STATE OF ALASKA ITB NUMBER 2515N021F AMENDMENT NUMBER 7

ITB TITLE: Aggregate, Stockpiled, Multiple Grades, Multiple Locations, Denali Highway, AK, Federally Funded

SURVEY GUIDANCE

MS 52-1-034-5
MP 56 Denali Highway
Within Unsurveyed Township 22 South, Range 5 East, F.M.

Meander Corners

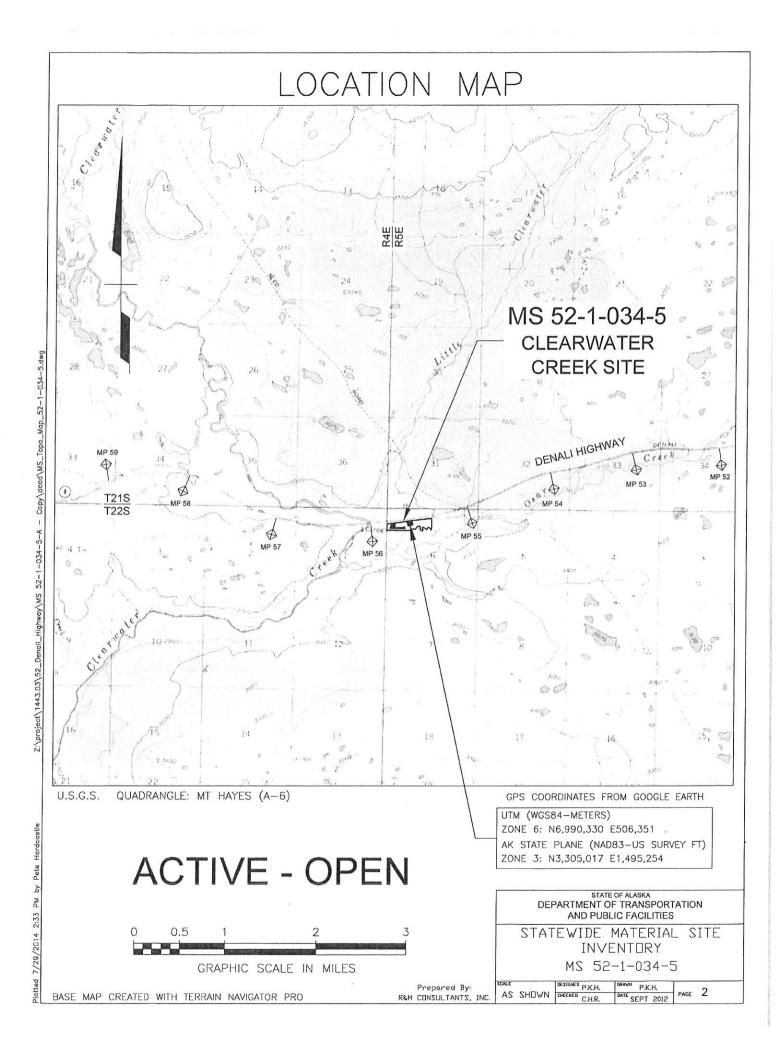
The ordinary high water mark of Oscar Creek forms a portion of the southerly boundary of this Material Site. Use customary survey procedures in setting Witness Corners to the Meander Corners, and reporting the meanders of Oscar Creek.
